29 June 2020

32 THE STRAND, WHALE BEACH
Request for modification under Section 4.55(1A) to Development Consent
DA2019/0913 to alter the approved development

Figure 2 – the garage roof is significantly lower than the main roof ridge

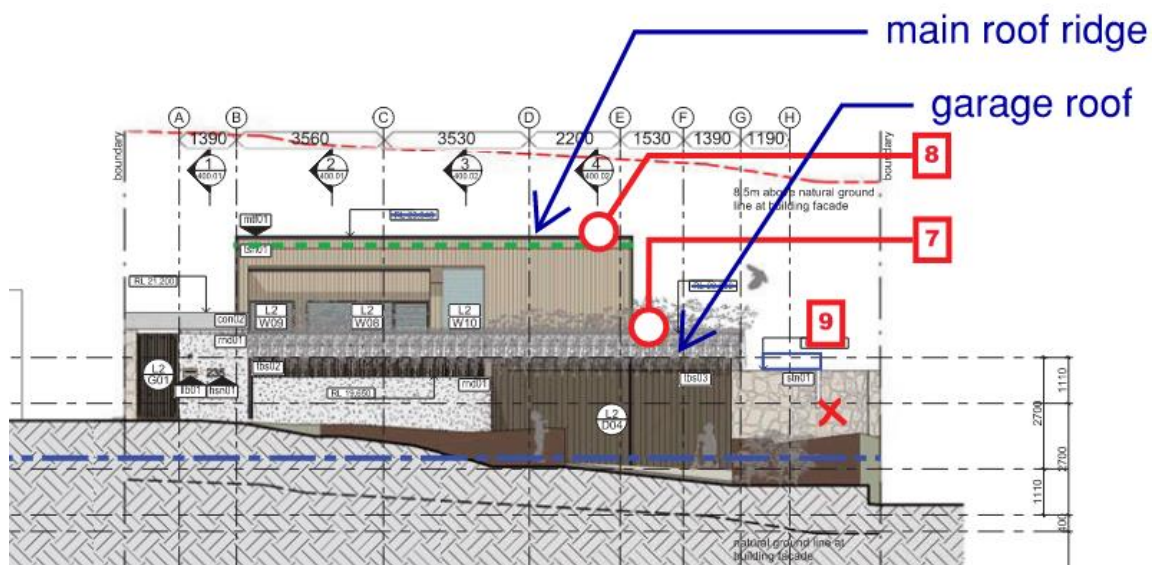
- Views – the proposed modifications involve a 150mm increase in the height of the approved garage roof. This is effectively offset by a lowering of the main roof ridge by 290mm to RL22.750, which involves a larger expanse when viewed from the west. This change is anticipated to improve views from properties to the west. Given the lower level (RL 22.850) of the garage roof (relative to the main roof ridge) together with the 290mm lowering of the main roof ridge, overall, the proposed modifications are likely to result in an improved view sharing outcome, and are therefore assessed as appropriate in satisfying the provisions of the control.
